# UNITED STATES PATENT AND TRADEMARK OFFICE

APPLICATION NO.	FILING DATE	FIRST NAMED INVENTOR	ATTORNEY DOCKET NO.	CONFIRMATION NO.
10/068,304	02/05/2002	Shoji Hinata	9319S-000323	9656

# Office Action Summary

## DETAILED ACTION

Fig. 7

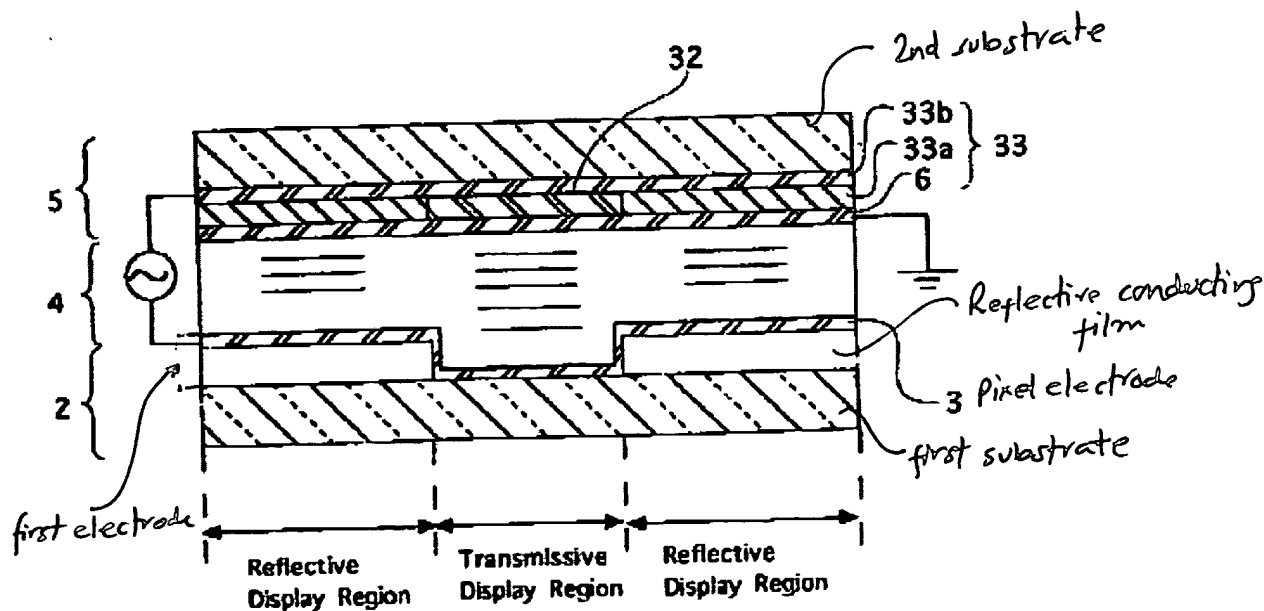
7. Kubota discloses and shows in Fig. 7, a transfective liquid crystal display device comprising:

- a reflective conductive film formed on the first substrate;
- a pixel electrode (3) (applicant's light transmitting metal oxide film) (page 4, paragraph 0055) conductive film so that the edge of the metal oxide film is in contact with the first substrate; and
- a light source (applicant's illumination means) irradiating the liquid crystal with light from outside the first substrate (not shown) (page 8, paragraph 0106).

Accordingly, claims 1 and 3 are anticipated.

As to claim 7, Kubota also shows in Fig. 7 that the reflective conductive film and the metal oxide form a first electrode for applying voltage to the liquid crystal layer.

As to claim 8, Kubota also shows in Fig. 7 that the device further comprising a second electrode (6) formed on the second substrate opposite to the first electrode, and a color layer (33a) provided corresponding to the crossing regions between the first and second electrodes.

As to claim 14, it is clear from Fig. 7 of Kubota that the area of the edge in contact with the first substrate is between 10-70%, preferably 30 to 50% of the area of one display dot to which the edge belongs.

Fig. 8

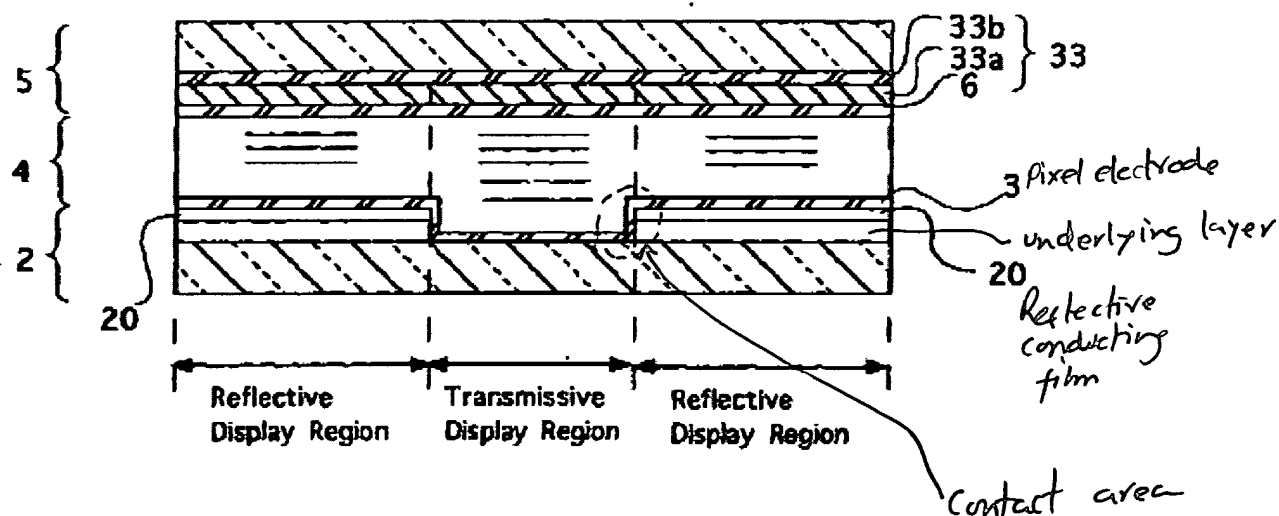
As to claim 2, Kubota shows in Fig 8, a transfective liquid crystal display device comprising:

- an underlying layer provided on the first substrate;
- a reflective conductive film (20) formed on the underlying film;

- a pixel electrode (3) (applicant's light-transmitting metal oxide) film laminated on the reflective conductive film (20) so that the edge of the metal oxide film (3) is in contact with the underlying film; and
- a light source (applicant's illumination means) for irradiating the liquid crystal with light from outside the first substrate (not shown).

Accordingly, claims 2 and 4 are anticipated.

As to claim 15, it is clear from Fig. 8 of Kubota that the area of the edge in contact with the first substrate is between 10-70%, of the area of one display dot to which the edge belongs.
